Access Compliance Report

Public Rights-of-Way

(Curb Ramps)

Intersection ID: 28929	Main Street: WADE_ARDREY_RD	Cross Street: CAMPBELL_HALL_CT	Location: SE
ADA ID: B4DD2B91326E	Ramp Type: BlendTrans1	Initial Pass/Fail: Fail	Overall Compliance: No
Severity Score: 8.75			
Codes/Mitigation Info/Possible Solution		Field Measurements/Component Compliance

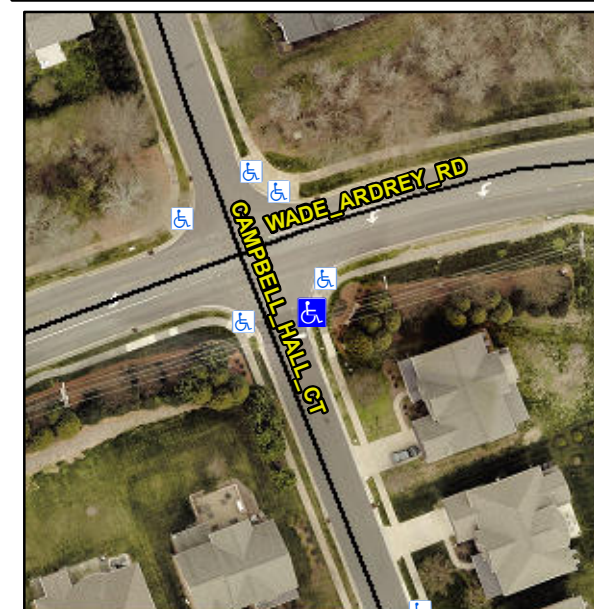
Not Found, R304.5.1

Compliance	Description	Data	Compliance	Description	Data
N/A	Ramp Length (in)	49.0	Yes	BlendTrans Slope (%)	3.4
No	Ramp Width (in)	43.0	Yes	BlendTrans XSlope (%)	0.4
N/A	Flare Type LT	N/A	N/A	Flare Type RT	N/A
N/A	Flare Slope LT (%)	N/A	N/A	Flare Slope RT (%)	N/A
N/A	Flare Traversable LT?	N/A	N/A	Flare Traversable RT?	N/A
N/A	Landing Length (in)	N/A	N/A	DWS Provided?	N/A
N/A	Landing Width (in)	N/A	N/A	DWS Contrast?	N/A
N/A	Landing Slope (%)	N/A	N/A	DWS Length (in)	N/A
N/A	Landing X Slope (%)	N/A	N/A	DWS Full Width?	N/A
N/A	Landing Curb? (Y/N)	N/A	N/A	DWS Offset (in)	N/A
N/A	Shared Landing?	N/A			
N/A	Gutter Ponding?	N/A	N/A	Gutter Slope (%)	N/A
N/A	Gutter Lip Ht (in)	N/A	N/A	Gutter X Slope (%)	N/A
N/A	Painted X Walk1?	No	N/A	Painted X Walk2?	N/A
	X Walk 1 Direction	To SW		X Walk 2 Direction	N/A
	X Walk 1 Width (in)	N/A		X Walk 2 Width (in)	N/A
	X Walk 1 Slope (%)	6.0		X Walk 2 Slope (%)	N/A
	X Walk 1 X Slope (%)	1.0		X Walk 2 X Slope (%)	N/A

N/A	Ramp inside XWalk1?	N/A	N/A	Ramp inside XWalk2?	N/A
	Road Slope (%)	1.0		Clear Space?	N/A
	Road X Slope (%)	6.0	N/A	Clear Space to XWalk (in)	N/A
N/A	Any Obstructions?	N/A	N/A	Storm Grate/Utility Hazard?	N/A
	Obstruction Type			Storm Grate/Utility Type	
		N/A			N/A
			Yes	Surface Condition? (G/P)	Good
			No	Curb Slope (%)	15.7

Remove & Replace Curb Ramp With Two New Directional Ramps or Equivalent.
